Topic	New GT - wind noise - water leak at cantrail seal
Market area	Worldwide Bentley (1WBE)
Brand	Bentley
Transaction No.	2037172/1
Level	EH
Status	Approval
Release date

New Continental GT

New GT - wind noise - water leak at cantrail seal

Figure 1

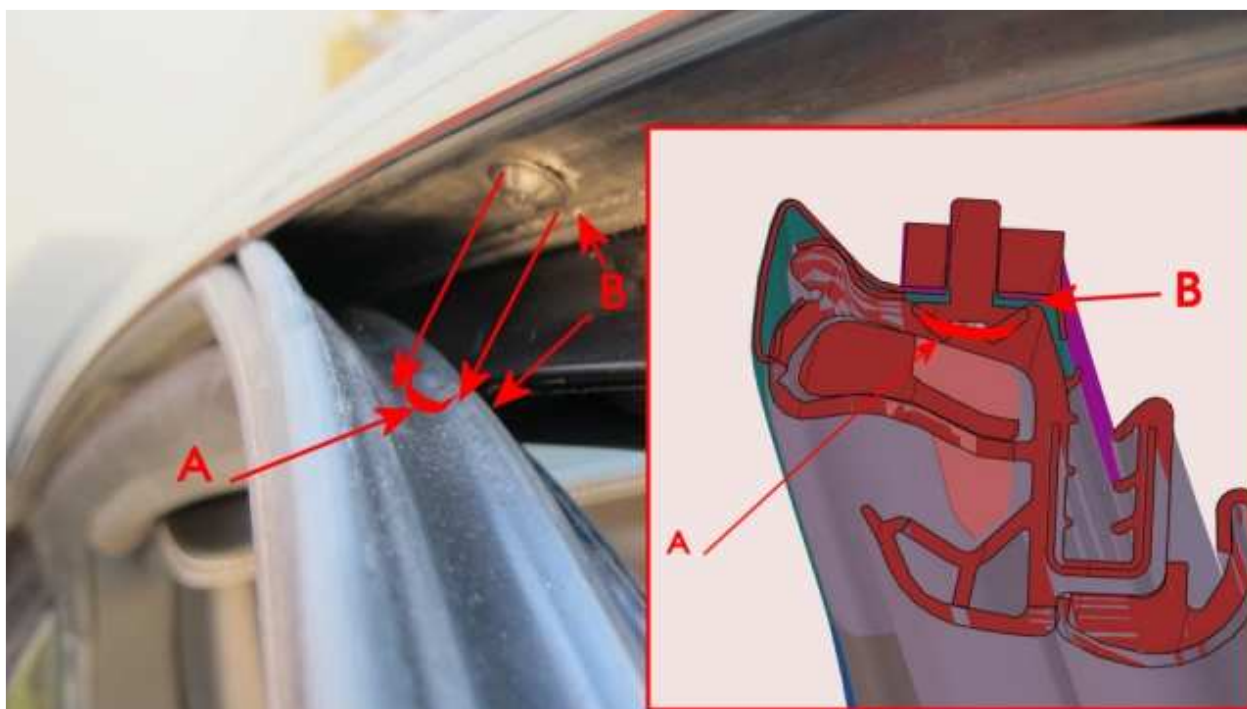
The cantrail seal may not have been correctly fitted during manufacture

The cantrail seal (C) forms the landing face for the vehicles side drop glass (see Figure 1). If this seal is not fitted correctly a gap can be produced where the glass interfaces with the seal resulting in wind noise and possible water ingress.

When fitting the seal ensure the head of the fasteners securing the roof brightware to the body are located in area (A) of the seal and that the ridge on the seal (B) is positioned between the inside edge of the fasteners and the inner edge of the roof brightware. When this is not the case the seal can be seen to deflect down where point B of the seal sits on top of the fastener, running a thumb along the seal edge will identify the high spot created in the seal by incorrect seal fitment.

An improved fitting process has been adopted

In the event of a concern relating to wind noise or water leak in the vicinity of the cantrail seal on New Continental GT then incorporate the following checks into your investigation ensuring the cantrail seal (C) is fitted correctly

Note: The head of the fasteners can be felt through the seal when the seal is correctly fitted but when correctly fitted the seal profile is not changed at the location of each fastener
